Addendum No. 1

Bid Opportunity: 7159-RW-22 – Smithson PS Office and HVAC Upgrades.

Closing Date: Monday, March 14th, 2022 2:00 PM

drawing number
A2.0

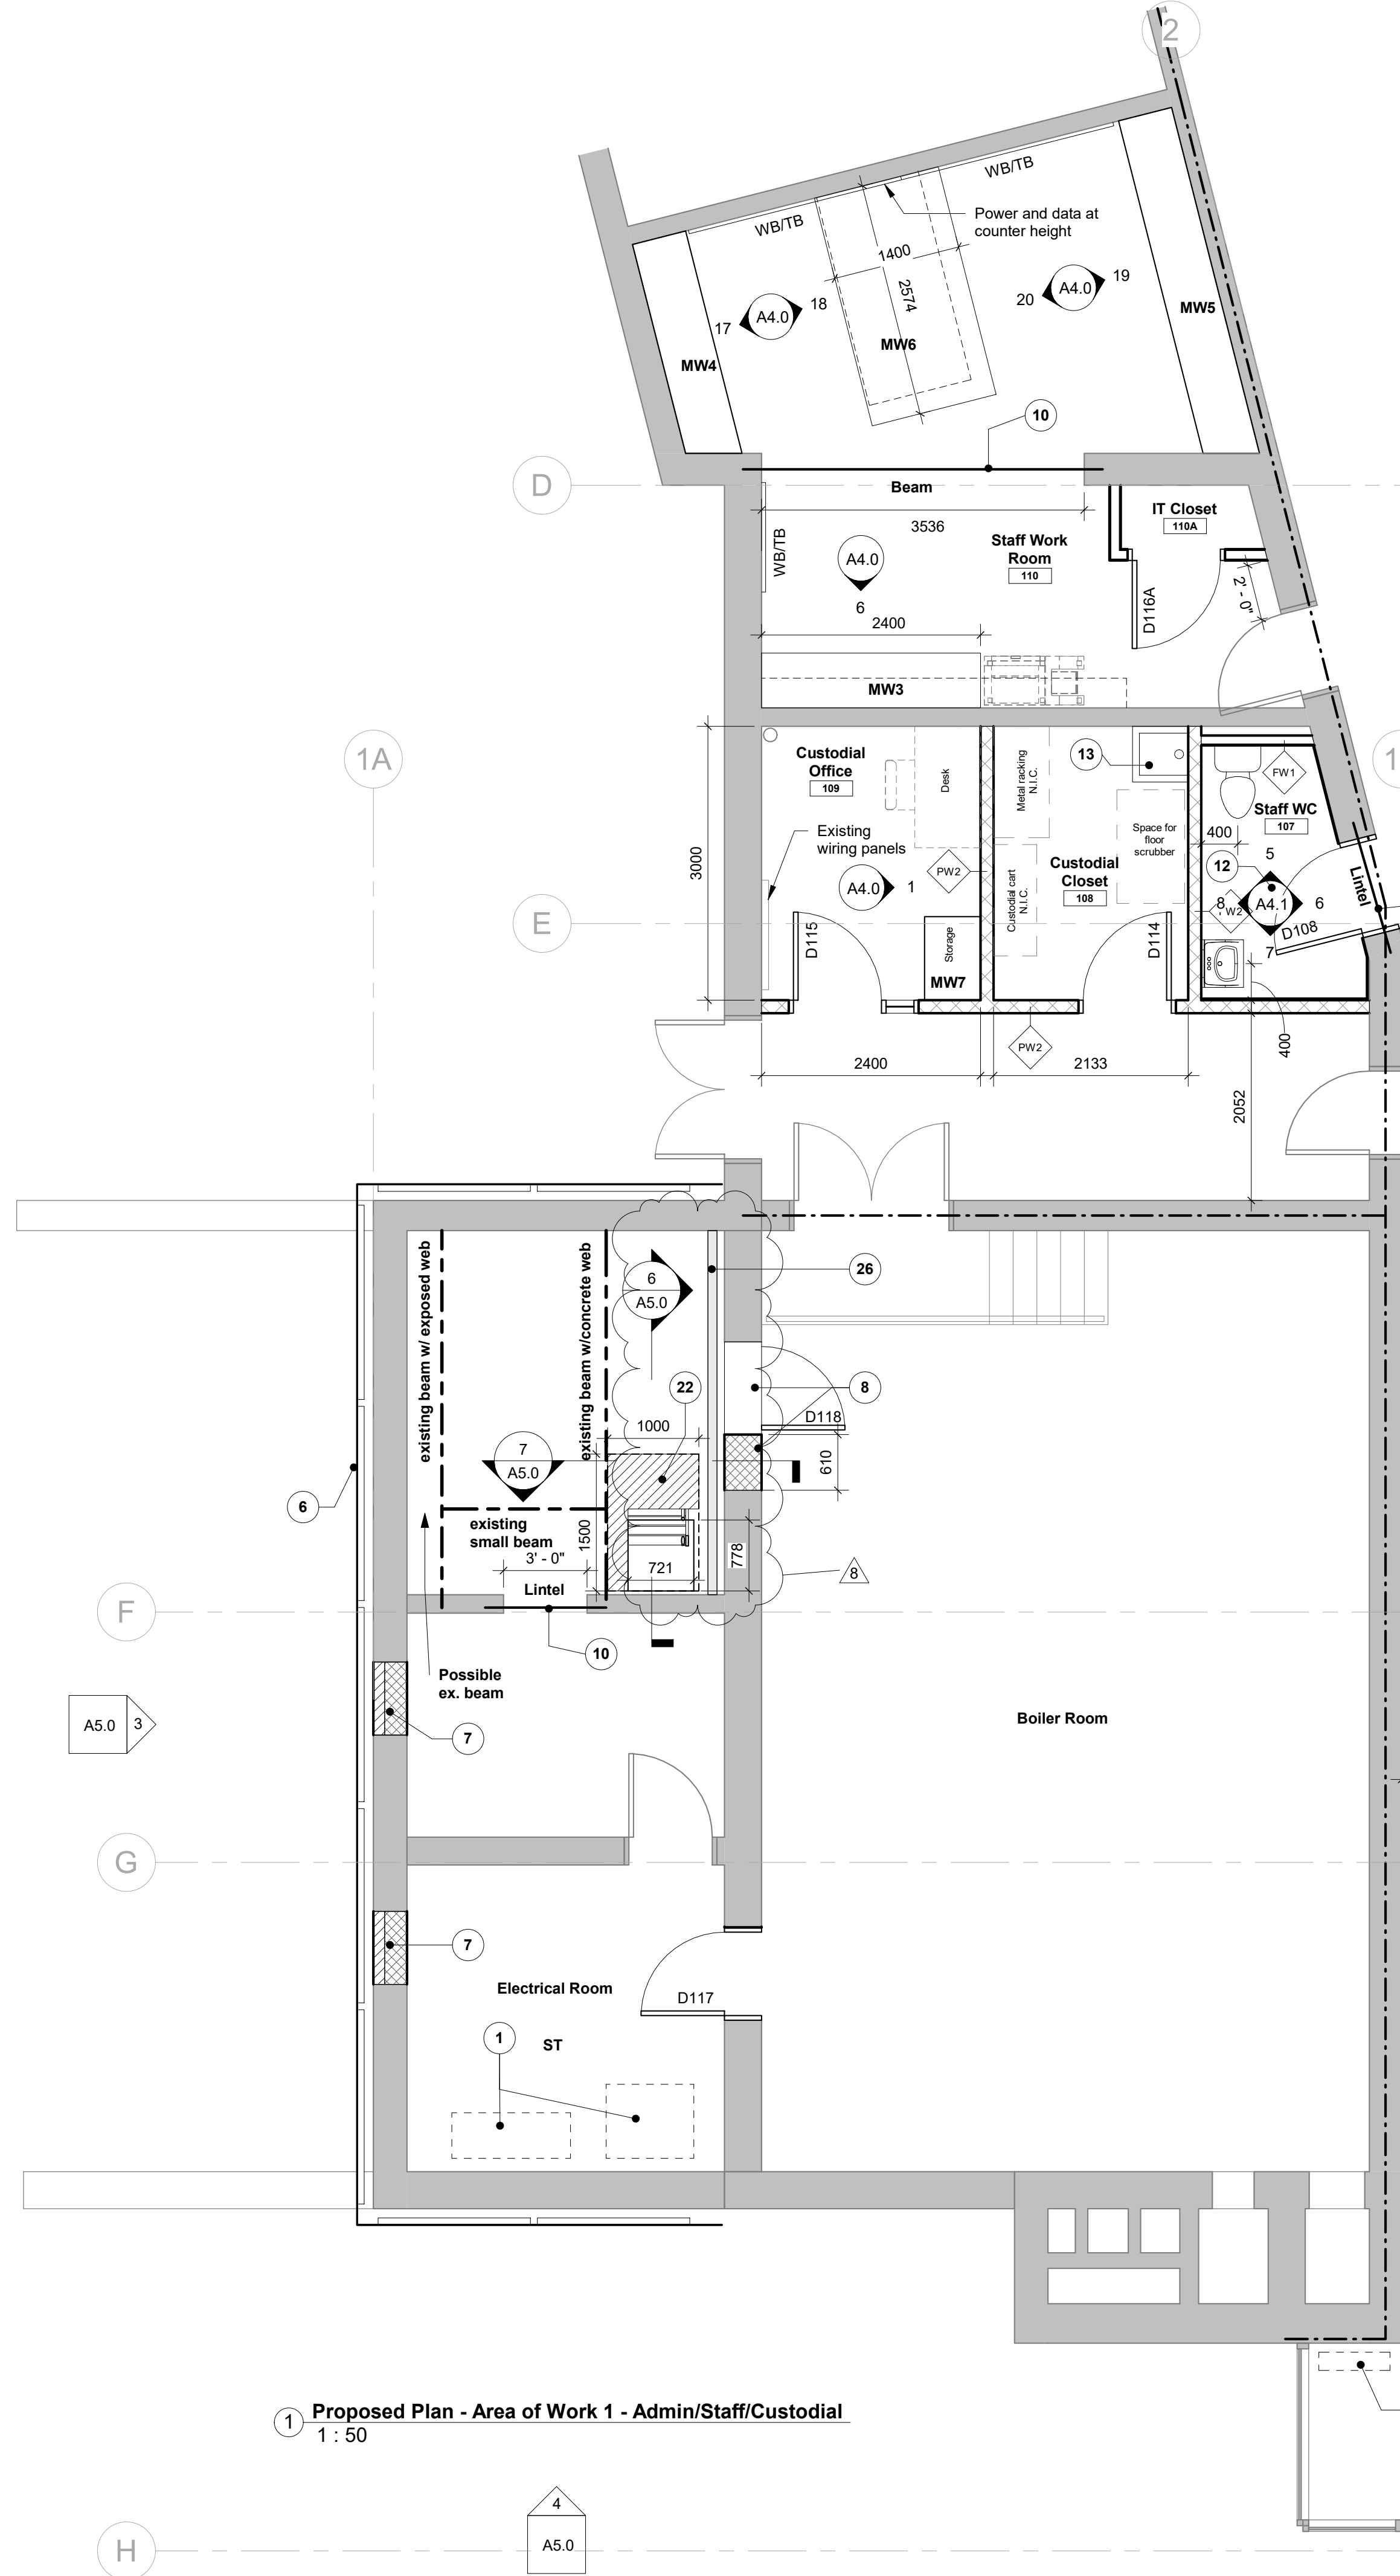
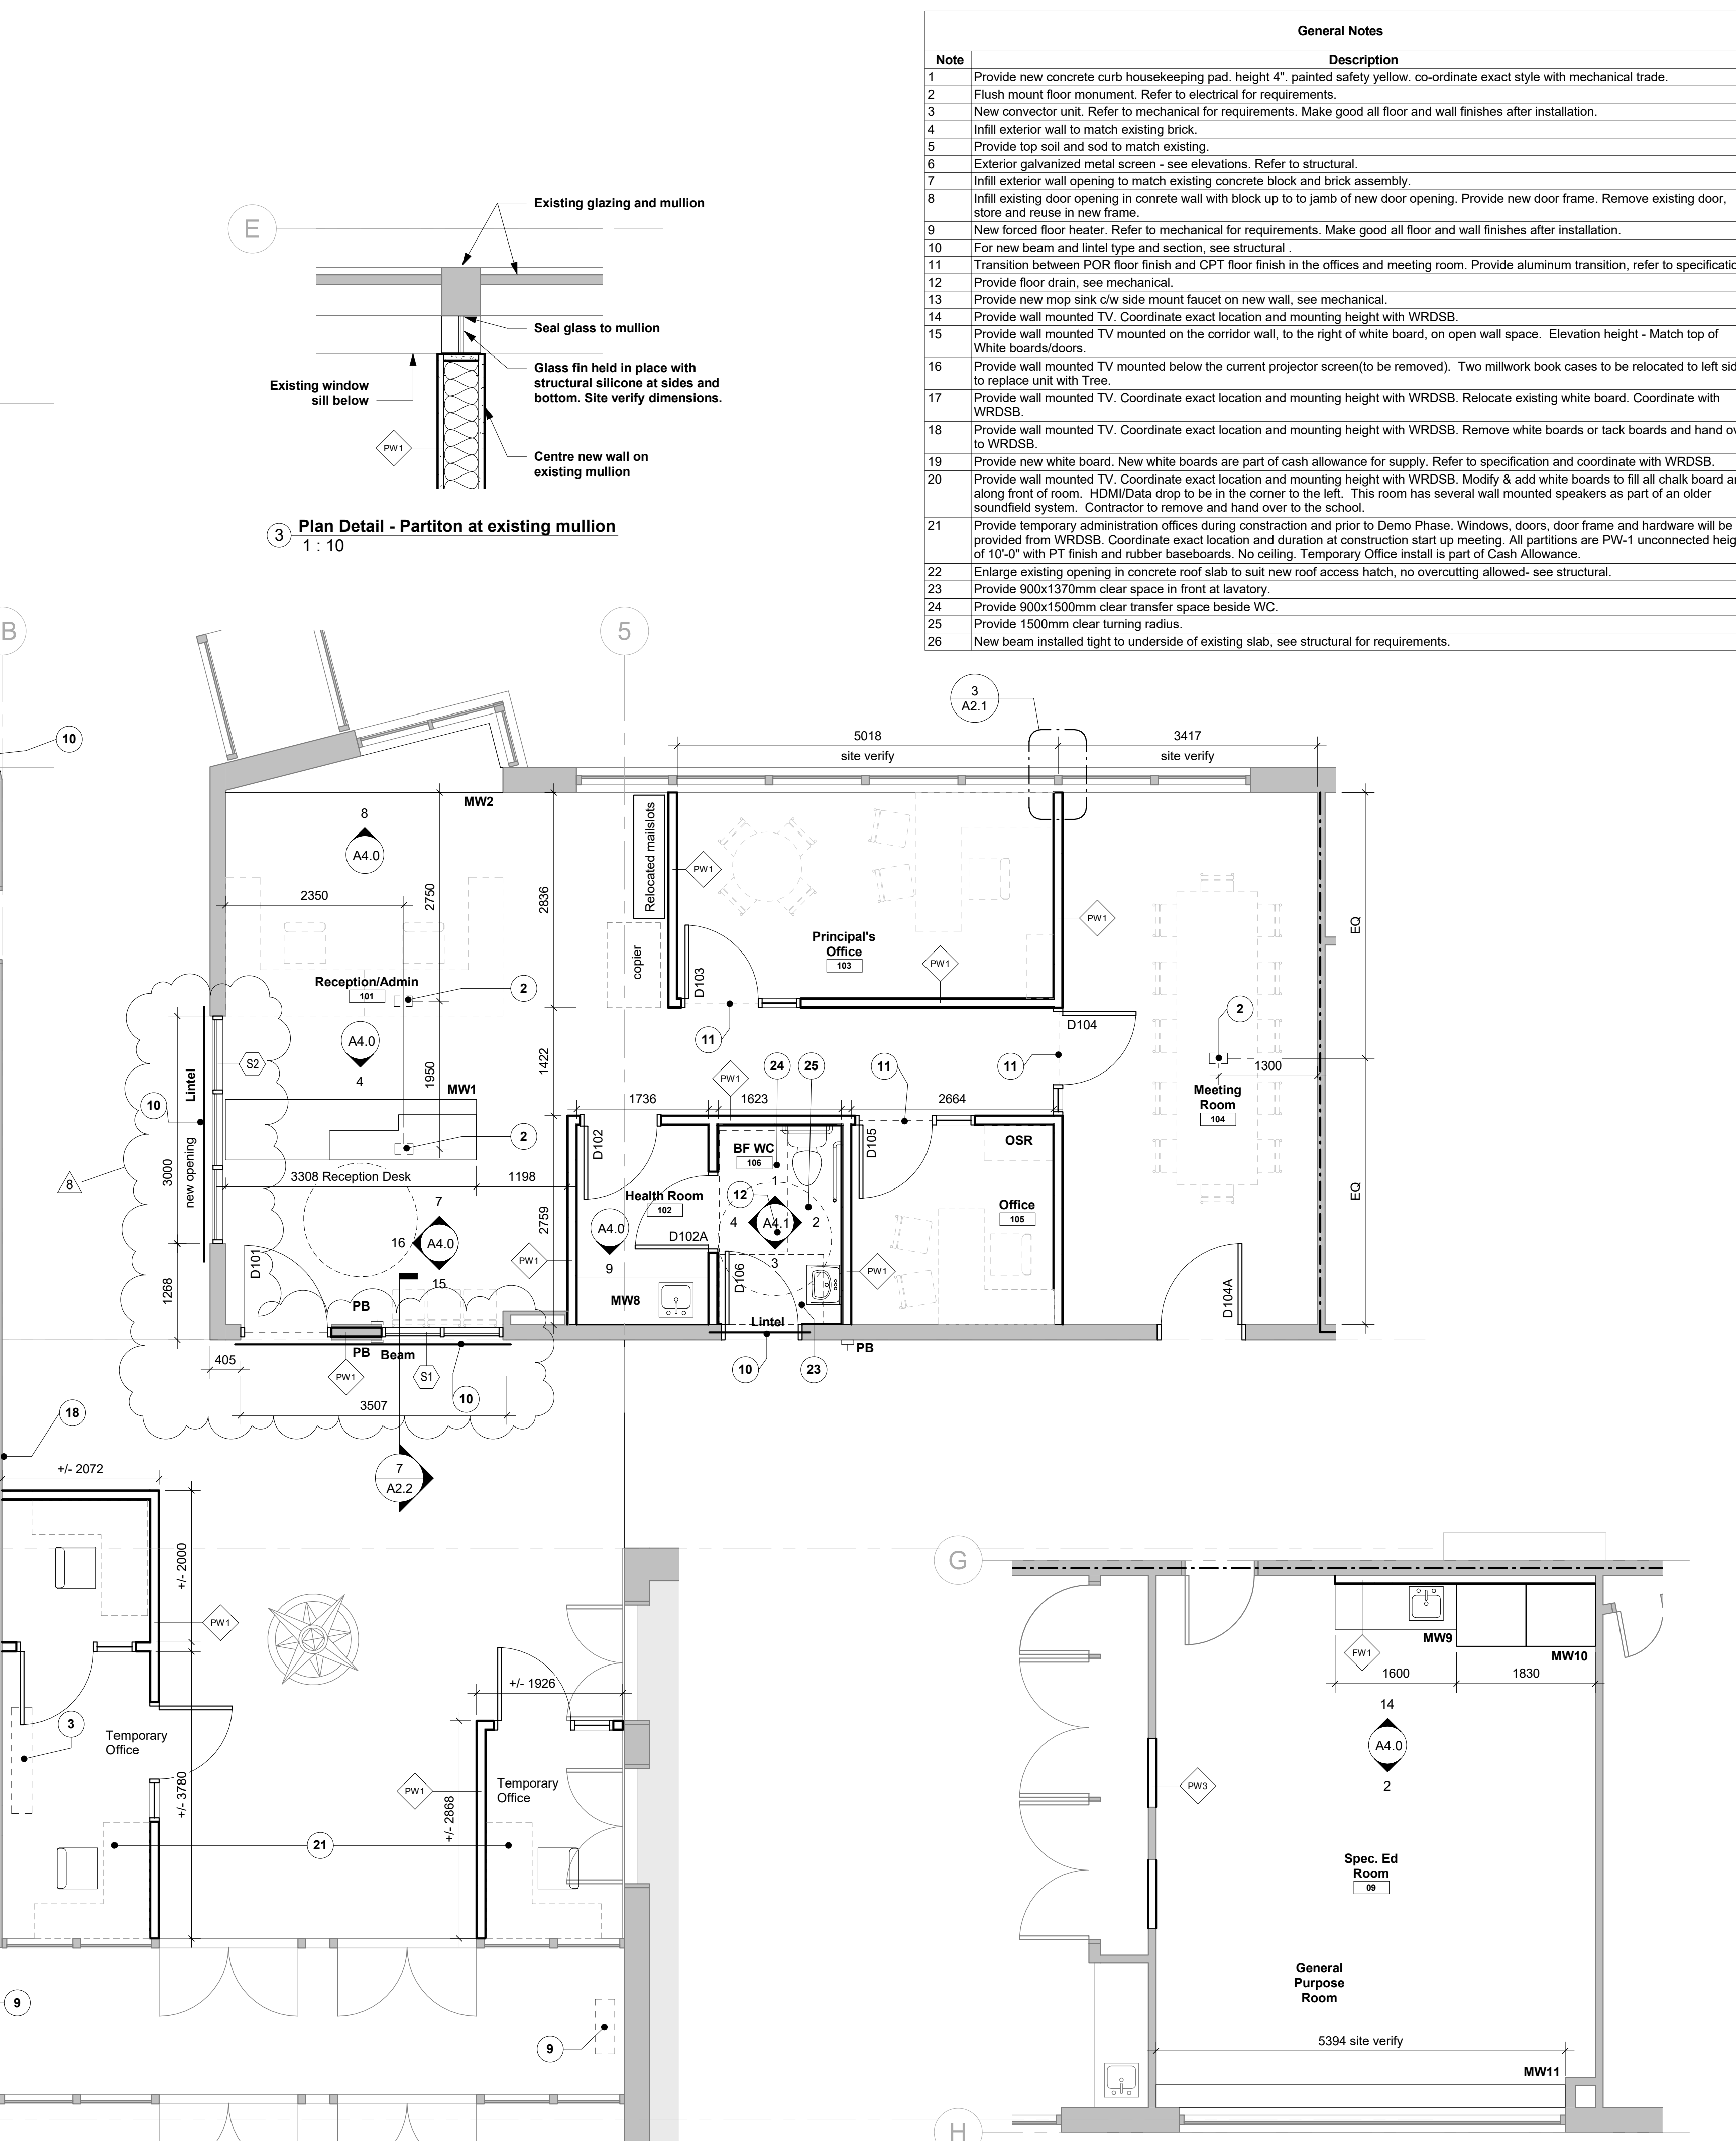
Refer to attached A2.0 Proposed Plans & Schedules for Revised Door Schedule (Revised D101, Added Fire Rating for D106, D108, and D114), Revised Screen Schedule (Added Fire Rating and Revised layout).

5 Section Detail - Typical Corridor Ceiling Bulkhead
1 : 20

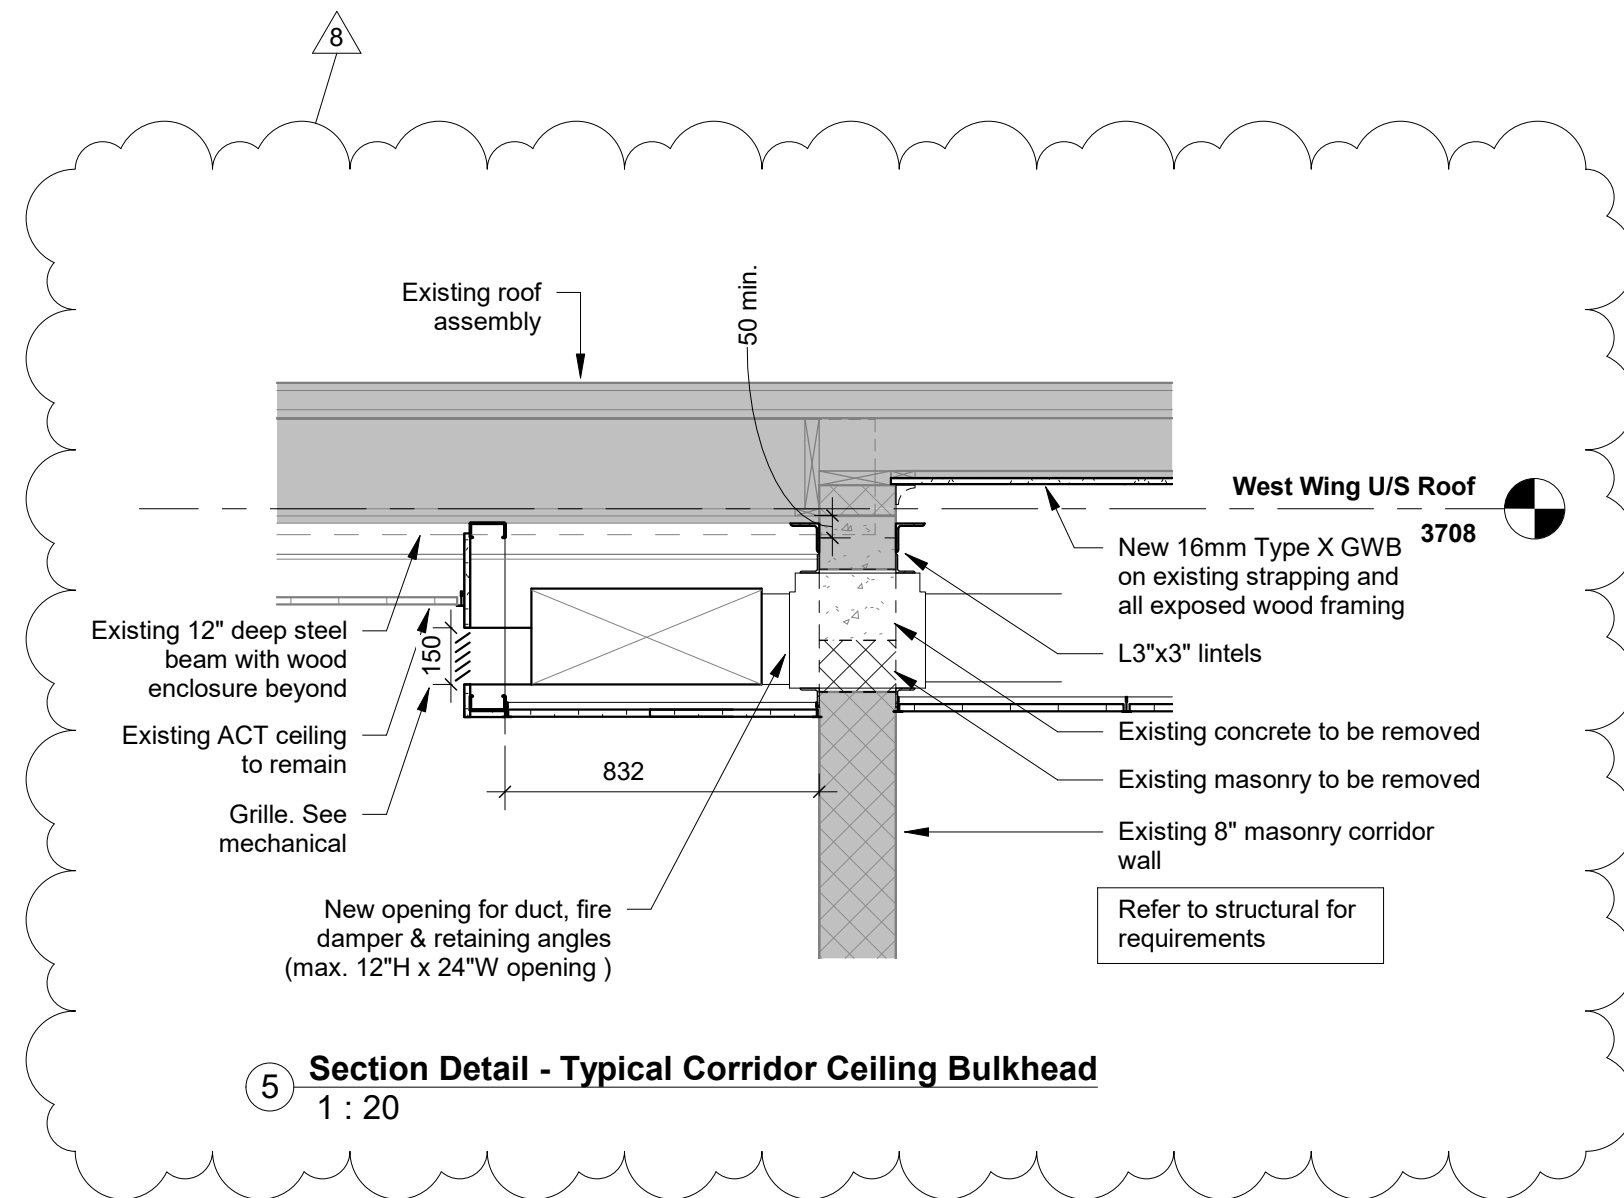
Refer to attached A2.2 Proposed RCP for Revised Detail 5 and Added Detail 7.
